**SITE PLAN AMENDMENT  
STAFF REPORT**

**City Council Meeting Date:**  
June 16, 2015

**Proposed Use:** Site plan for PD-823 for multifamily, townhouse & commercial uses

SP-15-001

SITE PLAN  
SCALE: 1"=100'

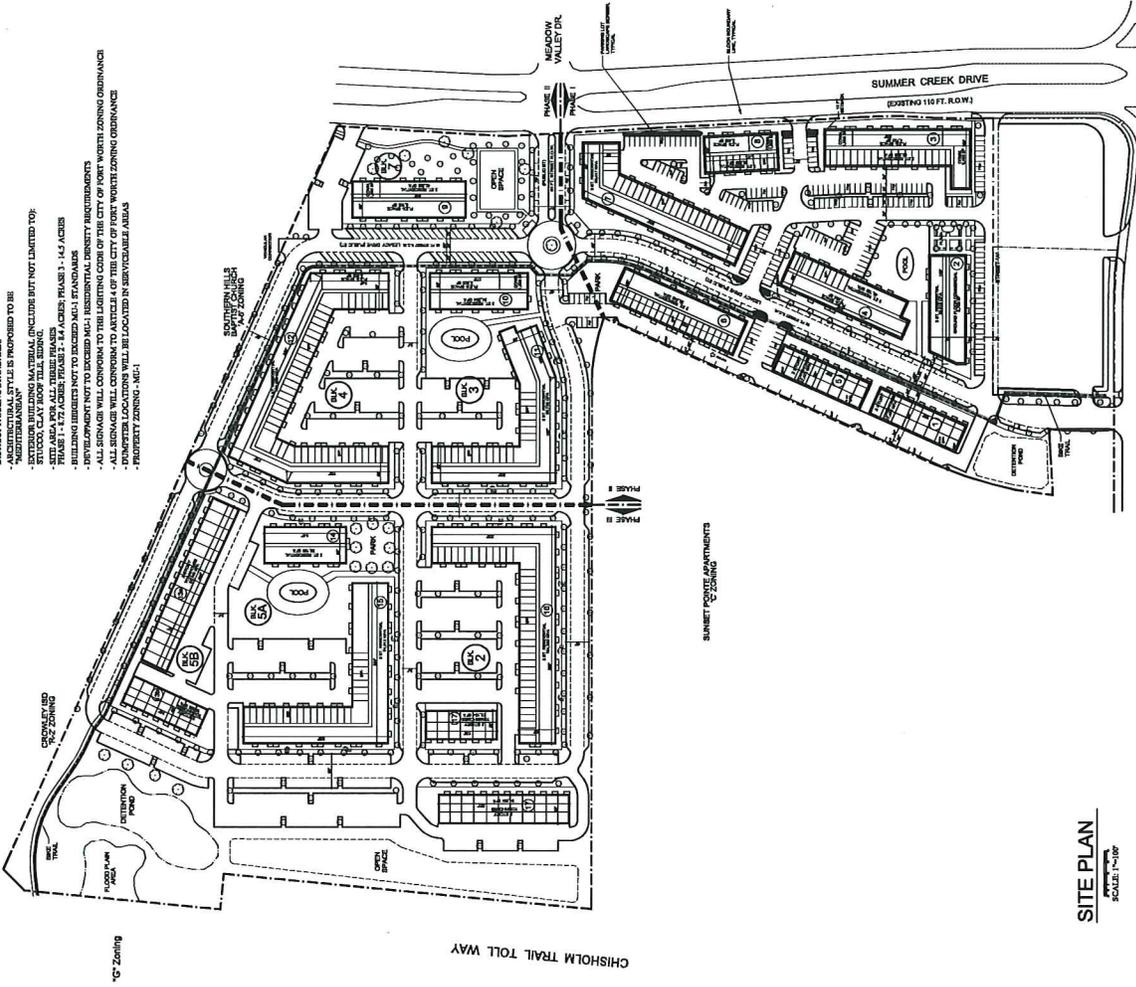
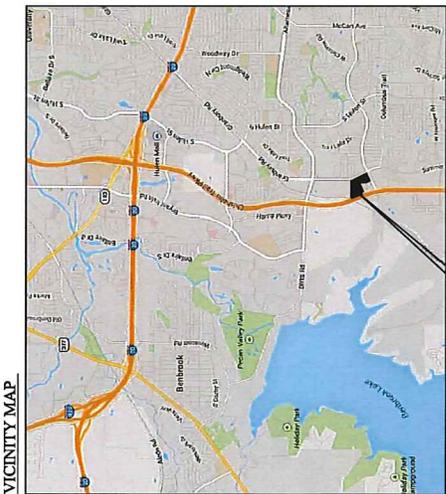
The site plan as submitted is not in general compliance with the Zoning Ordinance regulations. The key deficiencies are:

1. Block 5 has a perimeter of 1,830 feet. The subdivision ordinance limits MU projects to 1,600 feet block perimeters. You will need to break up that block with a street or public access easement or seek a waiver from the City Plan Commission.
2. Revise the site plan for on-street parking to 45' angled parking along Street "A" if the 24ft. drive aisle is being requested. {TPW needs a minimum of 30ft. for 90 degree angled parking on street}.
3. All proposed townhomes shall be reflected and indicated on individual lots. (no waiver)
4. All parking areas for the townhomes and for the multifamily shall be indicated on the site plan

Traffic Impact Analysis - Submit a Traffic Impact Analysis (TIA) for TPW approval. Include bicycle and pedestrian movements in accordance with the street design guidelines as the proposed development is located adjacent to a school site. An update of the traffic study is required to reflect the changes in trip generation from the previously approved study. The revised traffic study must be approved prior to review and consideration of the revised preliminary plat.

Driveway Locations - Driveway location must not interfere with intersection function. The driveways along Street "A" shall be spaced a minimum of 75' apart from each other to reduce turning movement conflicts. TPW prefers these to be aligned to create a four-way intersection.

Head-in Parking - Head-in parking must comply with ordinance #17517. A minimum of a 100ft. throat depth is necessary at the intersections with Summer Creek Dr. and Sycamore School Rd. No head in or parallel parking will be permitted within this 100 ft to reduce vehicles stacking onto the arterial roadways. Revise the on-street parking to 45' angled parking along Street "A" if the 24ft. drive aisle is being requested. TPW needs a minimum of 30ft. for 90 degree angled parking on street. This same will apply to the access easements located throughout the project. Special Needs Note – No parking should be placed in the approach areas of the traffic circle within the development in order to reduce conflicts as well as to allow traffic to flow through the circle freely. Clearance of 100 to 150 ft. from the circle is optimal for vehicle and pedestrian maneuvers.

Sidewalks - Sidewalks and street lights are required for all public and private streets and public access easements as per City of Fort Worth Standards. Sidewalks are required to be a minimum of 6ft. when adjacent to head in parking spaces.

1. The site plan as submitted does not comply with the preliminary plat, PP-12-003, Summer Creek Station as approved by the City Plan Commission. A Revised preliminary plat will be required. The changes from the preliminary plat will require a new submittal. Anything that requires waivers from the City Plan Commission will necessitate a new submittal.

a) The public street as shown to along the northern boundary simply terminates on the site plan without providing a cul-de-sac. A waiver from the City Plan Commission will be required.

b) Moving the public access easement to the south along Summer Creek Drive will create excessively long block faces and block perimeters. Waivers from the City Plan Commission will be required.

5. The boundary shown adjacent to Chisholm Trail Parkway is not consistent with what is shown on the approved preliminary plat.

6. Confirm with TPW, but drive aisles between two rows of head in parking must be a minimum of 30 feet wide. Most locations are only showing 24 feet.
